**PM5948**

**DART BOARD**

**TRANSCEIVER BOARD**

**ERRATA**

Fig.1:

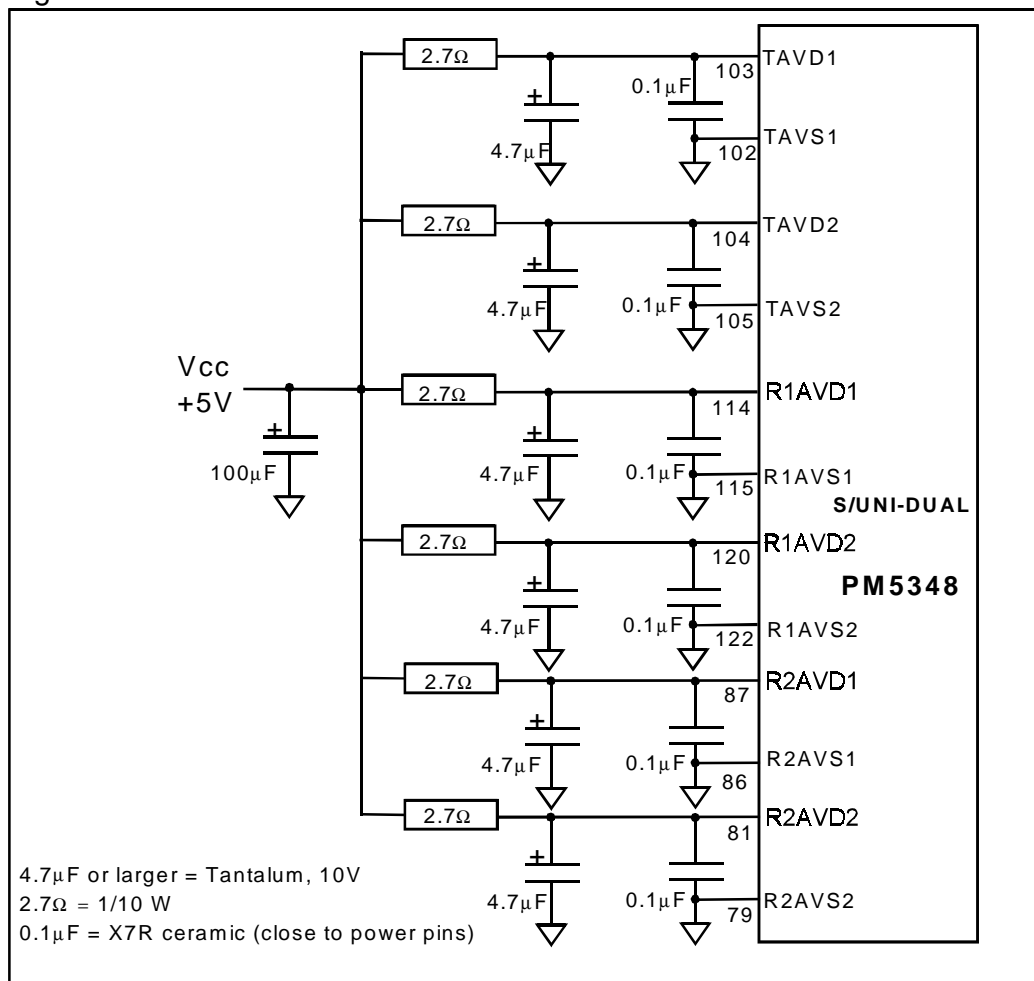
We have found that it may be desirable to include a low frequency power supply filter circuit, especially if powered by a switching power supply. This circuit is recommended to reduce noise seen by the S/UNI-DUAL analog power pins TAVD1, TAVD2, R1AVD1, R1AVD2, R2AVD1, and R2AVD2. All the other power pins must be de-coupled as recommended in the reference design schematic as per document PMC-960552 (R1).

The final analog power supply filter circuit should look like fig. 1 below. Optional ferrites may be used in series with each 2.7ohm resistor to reduce EMI. The recommended ferrites are made by Fair-Rite Corporation, P.N.# 2743019447.

The original schematic on page 4 of 10 of Appendix F of PMC-960552 must be modified as follows:

- 1) Replace the ferrites L3, 4, 7, 8, 18 and L9 with a  $2.7\Omega$  resistor.
- 2) Replace the  $1.0\mu\text{F}$  capacitor C89 with a  $4.7\mu\text{F}$  or larger, 10V Tantalum.
- 3) Replace capacitors  $0.1\mu\text{F}$  C80, 81, 91, 95 & C96 with a  $4.7\mu\text{F}$  or larger, 10V Tantalum.
- 4) Replace  $0.01\mu\text{F}$  capacitors, C2, 15, 19, 22, 88 and C82 with a  $0.1\mu\text{F}$  X7R ceramic.

Make sure that in the final version, the  $0.1\mu\text{F}$  ceramic capacitors are close to the IC pins. The  $2.7\Omega$  resistors can be low power 1/10 W.

Fig.2:

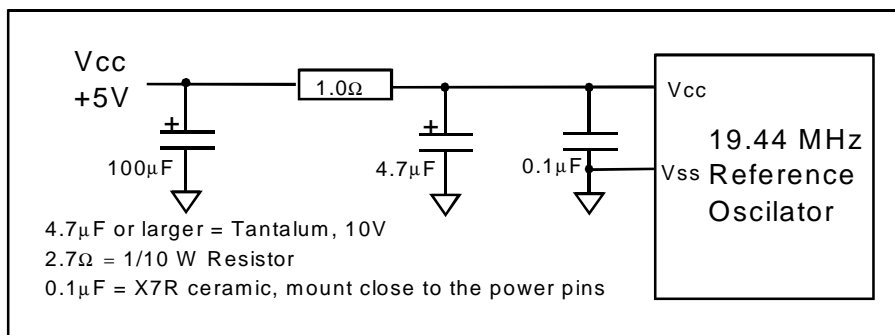
Oscillators are susceptible to noise on their power supply pins. The following change is recommended especially if powered by a switching power supply. The original schematic on page 1 of 10 in Appendix F of the PMC-960552 must be modified as follows:

The final power supply low pass circuit is shown below in fig. 2:

- 1) Replace L32 with a  $1.0\Omega$  resistor.
- 2) Replace  $0.1\mu\text{F}$  capacitor C157 with a  $4.7\mu\text{F}$  or larger, 10V Tantalum.
- 3) Replace  $0.01\mu\text{F}$  capacitor, C148 with a  $0.1\mu\text{F}$  X7R Ceramic.

Make sure the  $0.1\mu\text{F}$  capacitors are close to the IC pins. The  $1.0\Omega$  resistor can be low a power 1/10 watt.
